Service Bulletin

Bulletin No.: 20-NA-007

Subject: Hoot/Moan Type Noise While Driving at Slower Speeds

Brand:	Model:	Model Year:		VIN:		Engine:	Transmission:
		from	to	from	to		
Chevrolet	Malibu	2019	2020				VT40 CVT Automatic (MRG)

5479741

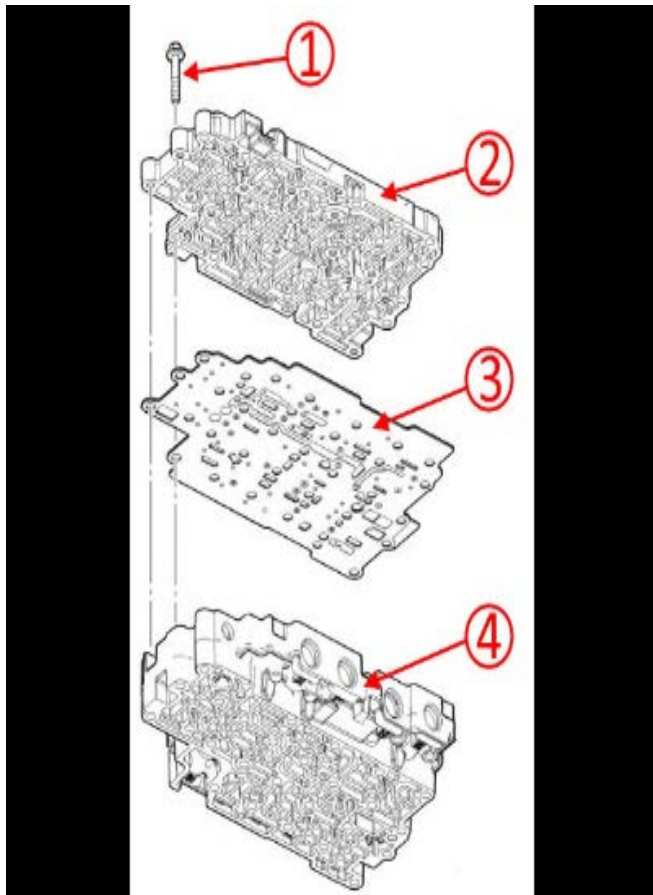
2. Remove the valve body bolts (1).
3. Using care, separate the spacer plate from the channel plate (2) and control valve (4).
4. Install the new spacer plate.
5. Assemble the control valve.

Tighten the bolts to 8 N•m (71 lb in).
